Assessment of Dam Safety

Coal Combustion Surface Impoundments (Task 3)

FirstEnergy Generation
Corporation

Bruce Mansfield
Power Plant
Little Blue Run Dam
Shippingport, Pennsylvania

FIGURE 9A

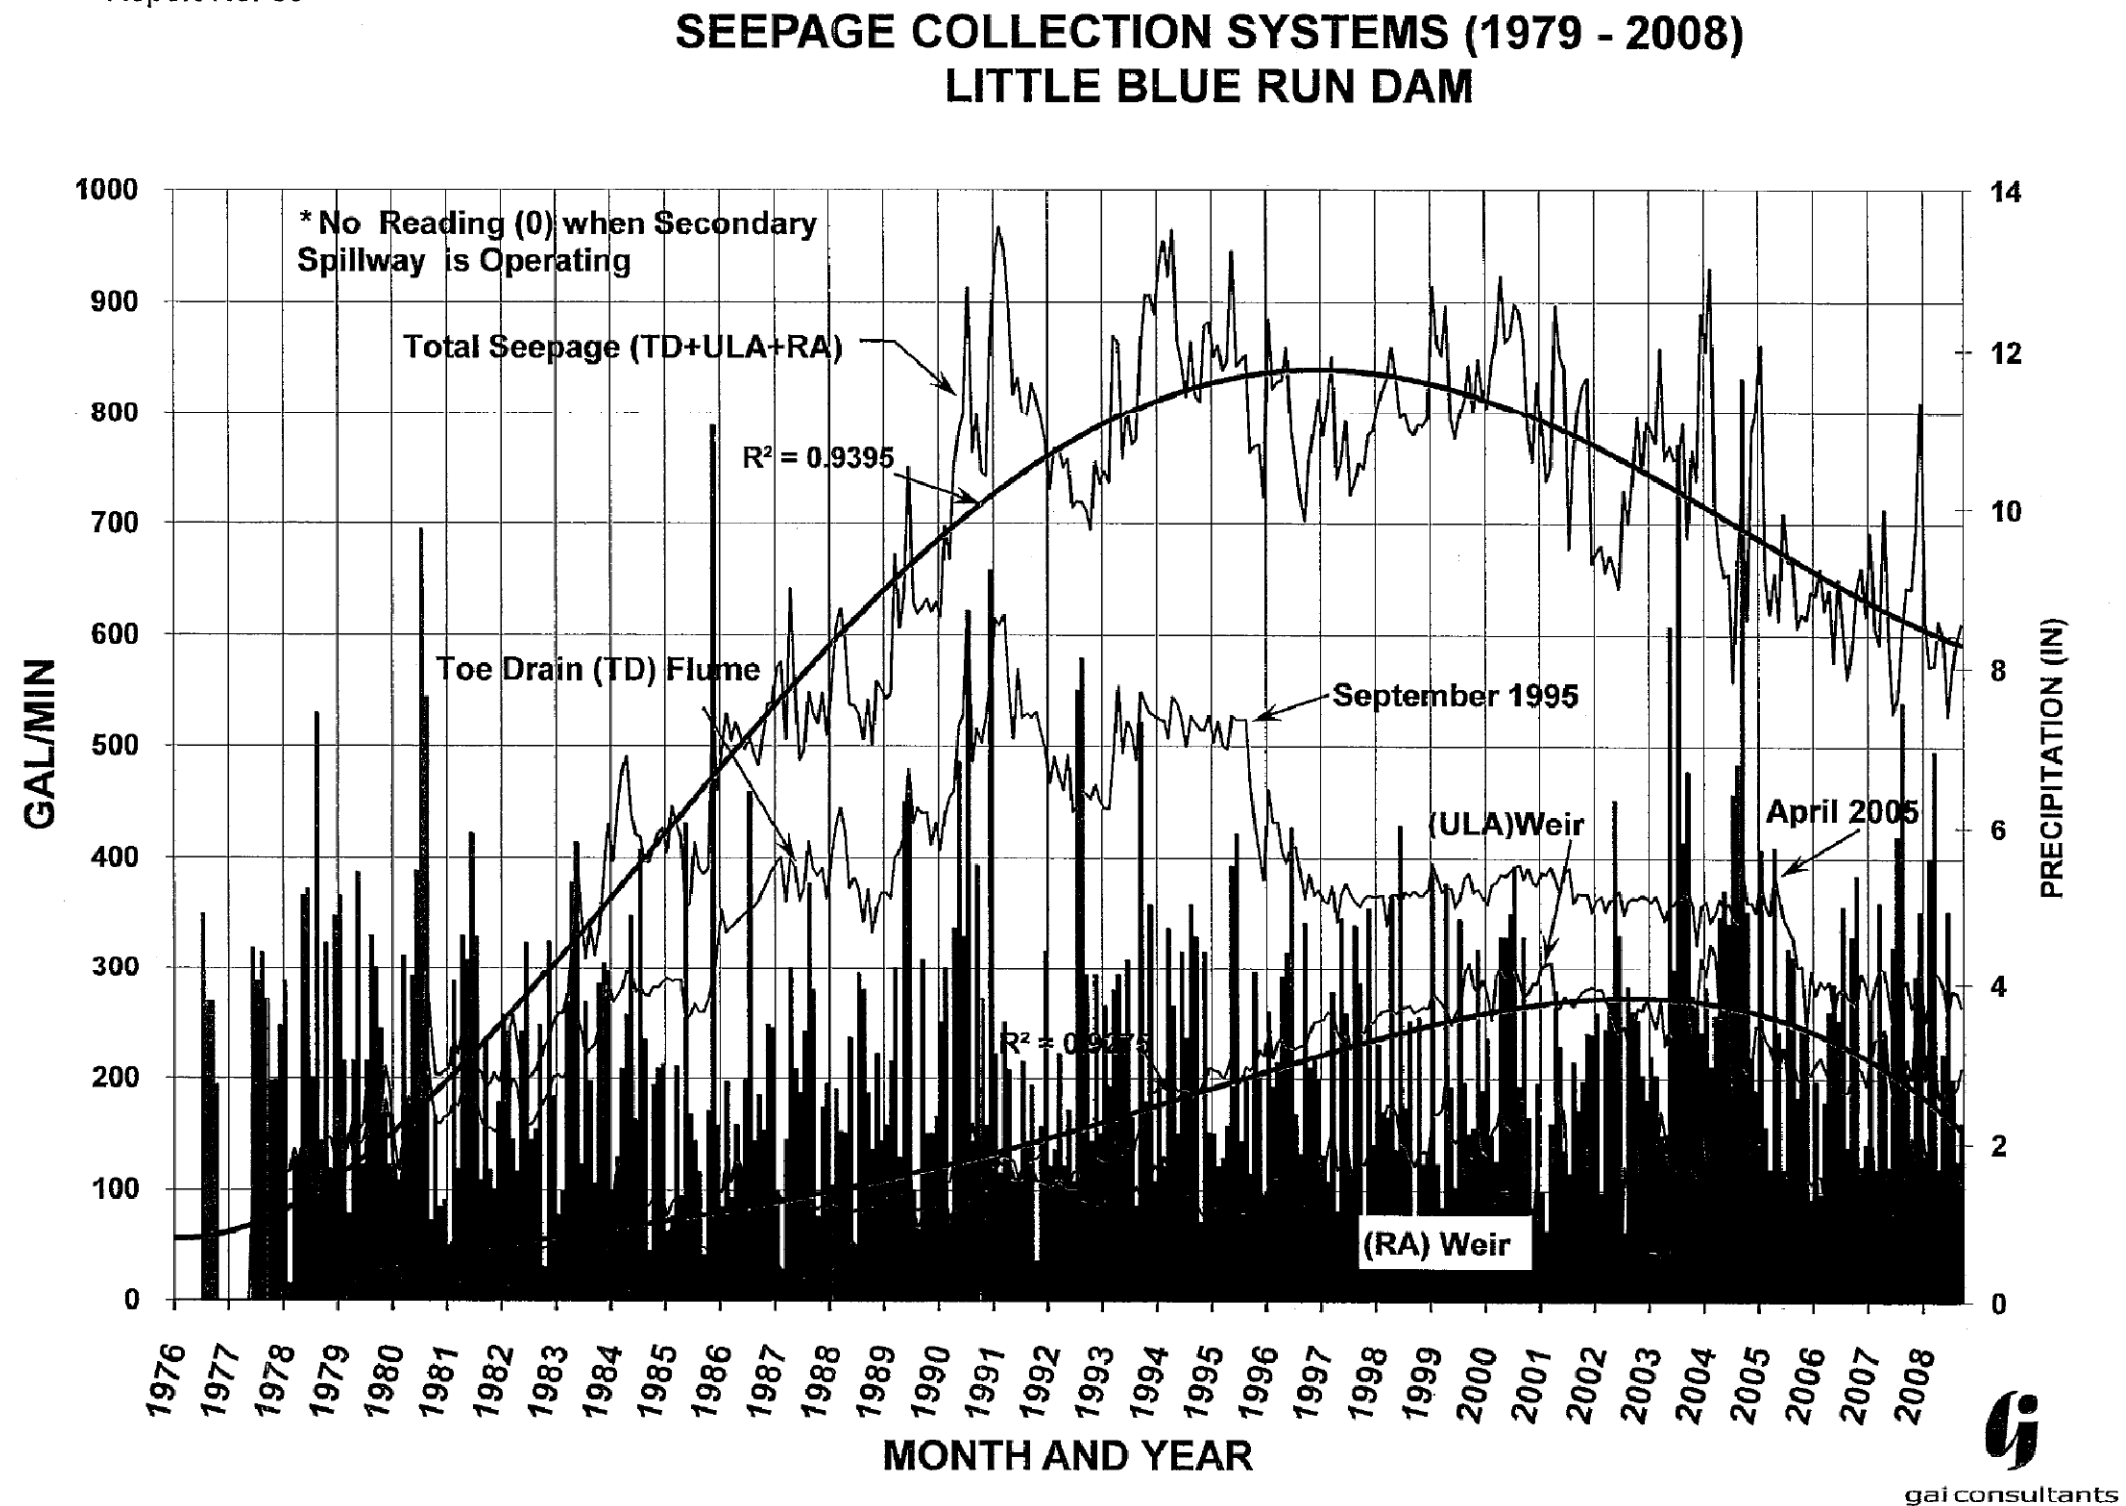
Discharge through these devices is measured daily. The data is reduced to obtain a monthly average for each device. The monthly average is combined and averaged for the current period to obtain the six-month average. Since weir data includes surface runoff, data collected on days where ½-inch of rainfall has been recorded is not tabulated for the six-month average calculation. The average base flow through the RA Weir is plotted for data collected only when the secondary spillway is not discharging. Plots of seepage from these weirs are shown on Figure 9A and Figure 9B.

Drawing Copyright © 2010 CH2M 111 Winners Circle, PO Box 5269 - Albany, NY 12205-0269 Main: (518) 453-4500 - www.ch2m.com	PIEZOMETER LOCATIONS		PROJECT NO. 20085.8000
	LITTLE BLUE RUN DAM SHIPPINGPORT, PENNSYLVANIA		DATE: 02/2010
			FIGURE 10

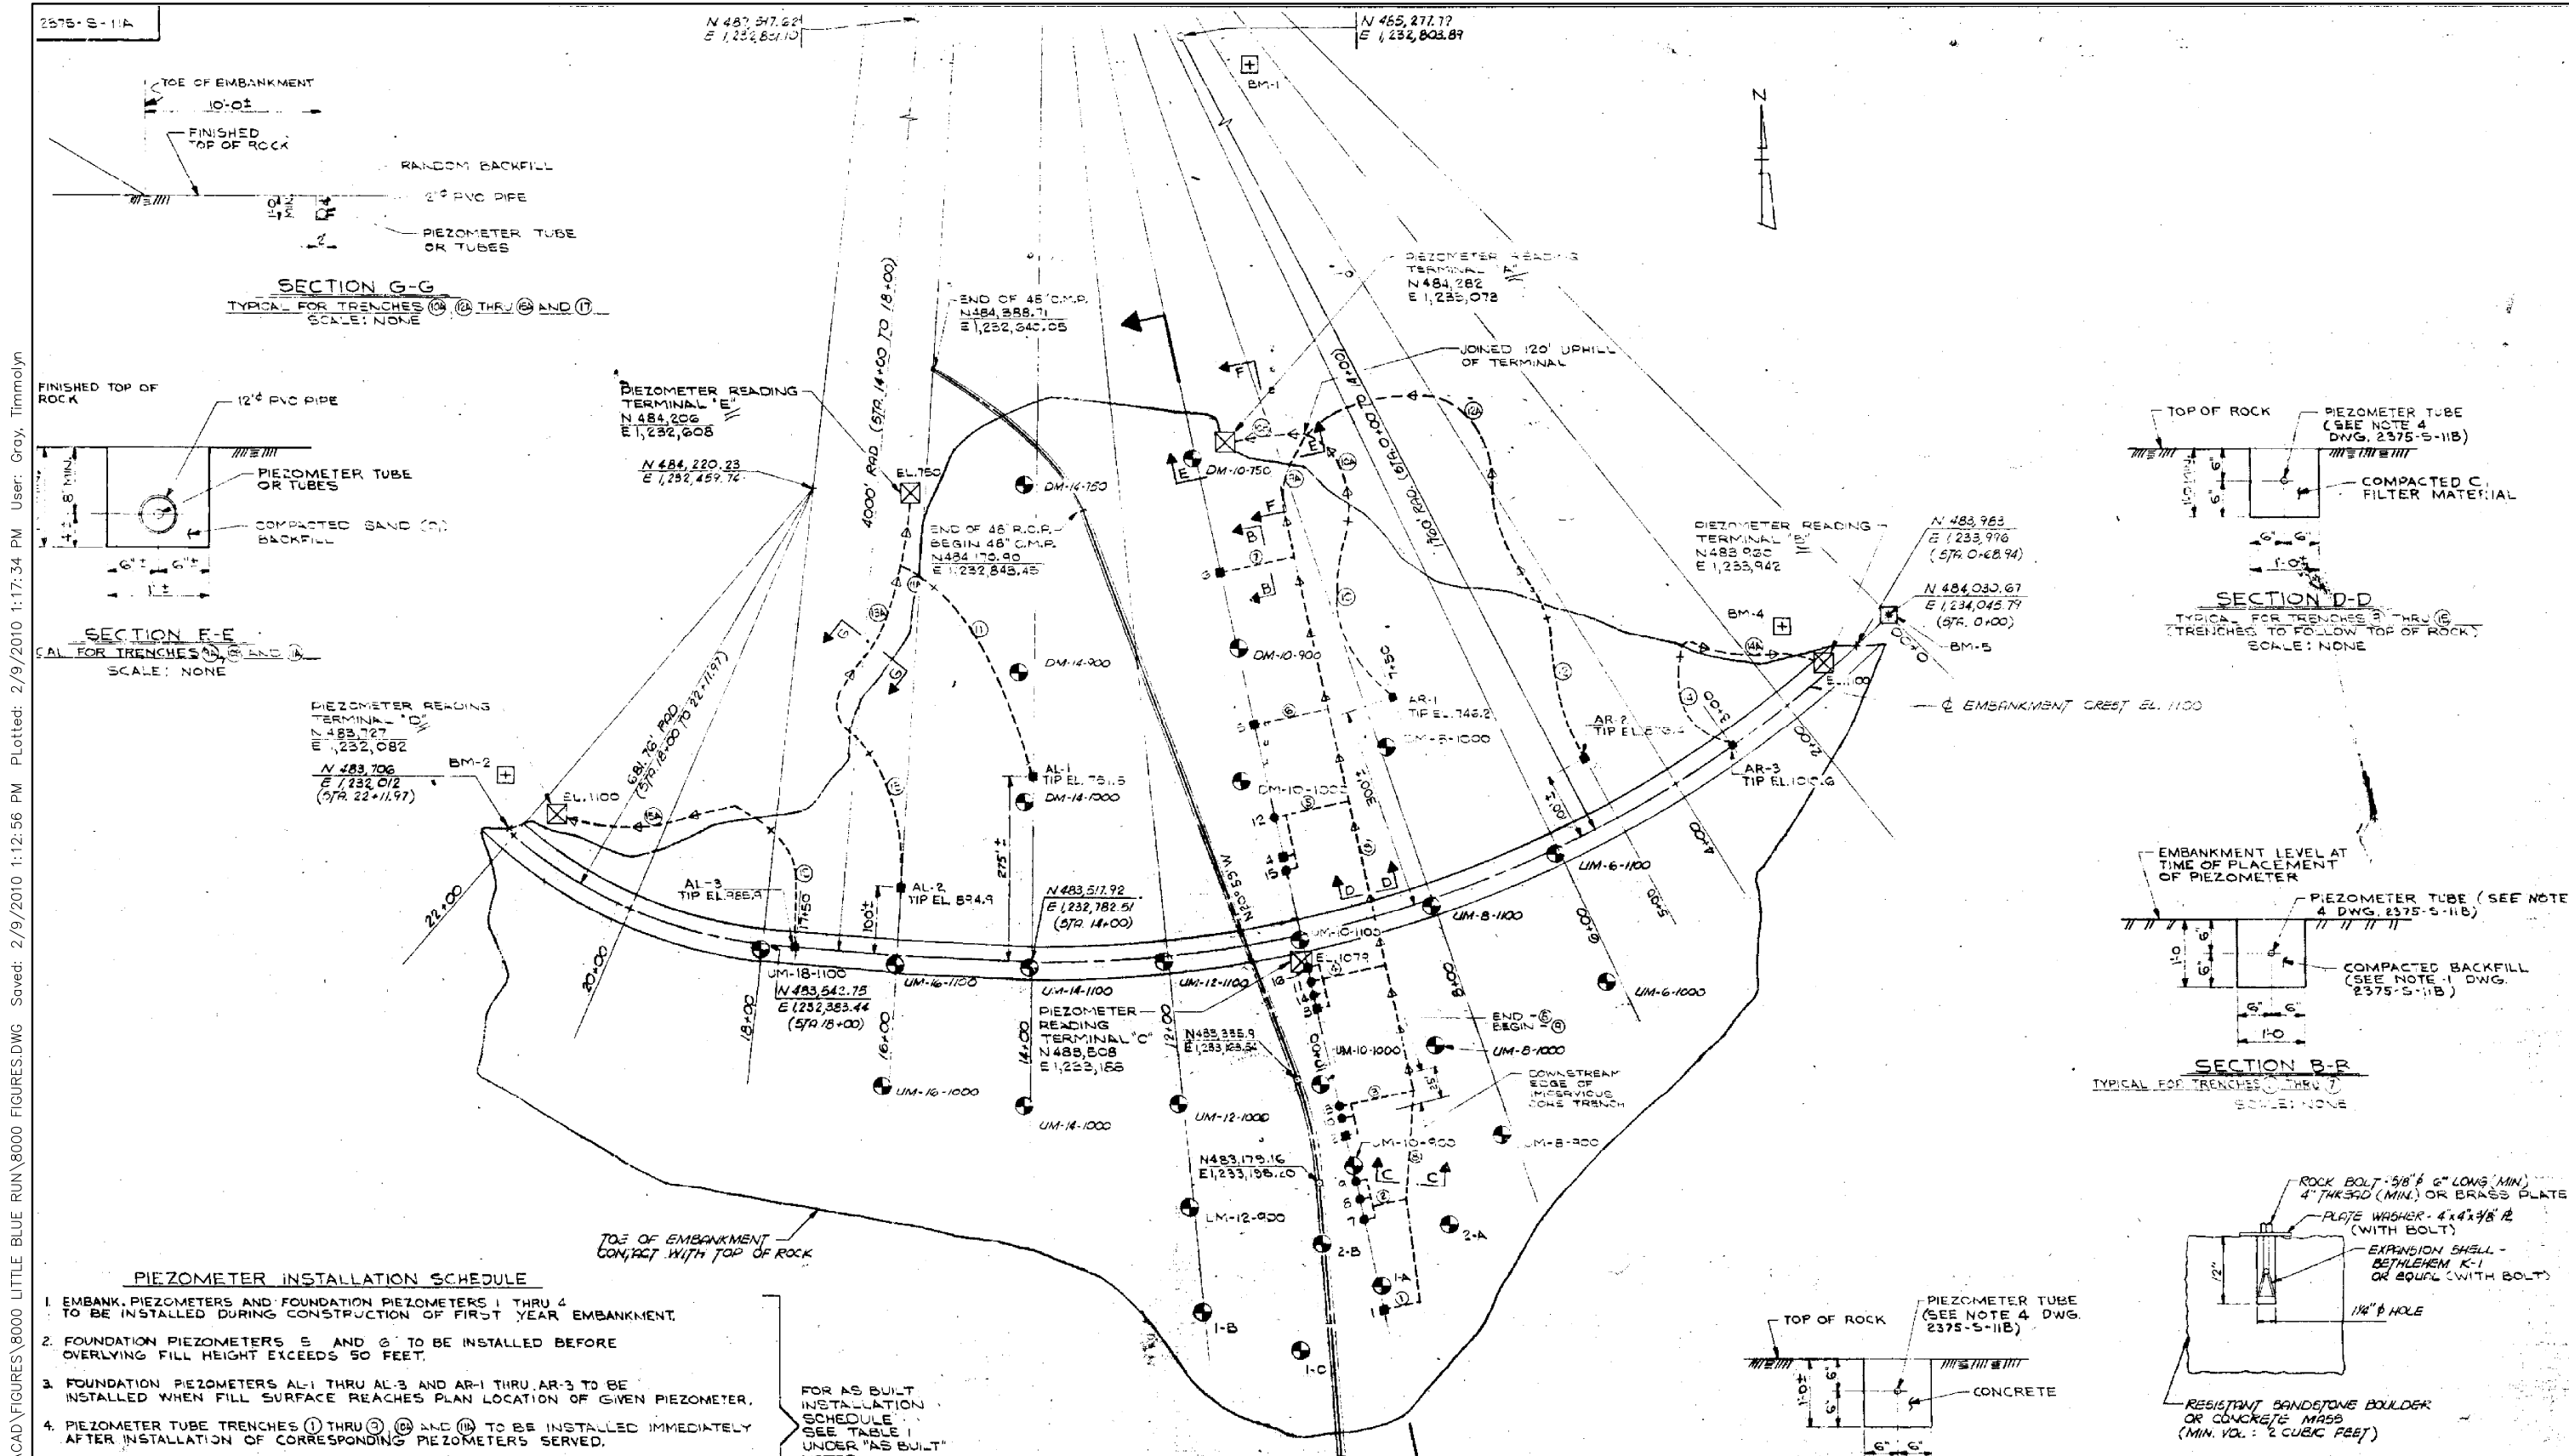
and 2 well points installed, 16 have reportedly malfunctioned, three yield questionable data according to FirstEnergy's consultant and 5 are performing satisfactorily. Figure 10 shows the location of the piezometers and Figures 11A through 11C shows the piezometer data from 2000 to December 2008.
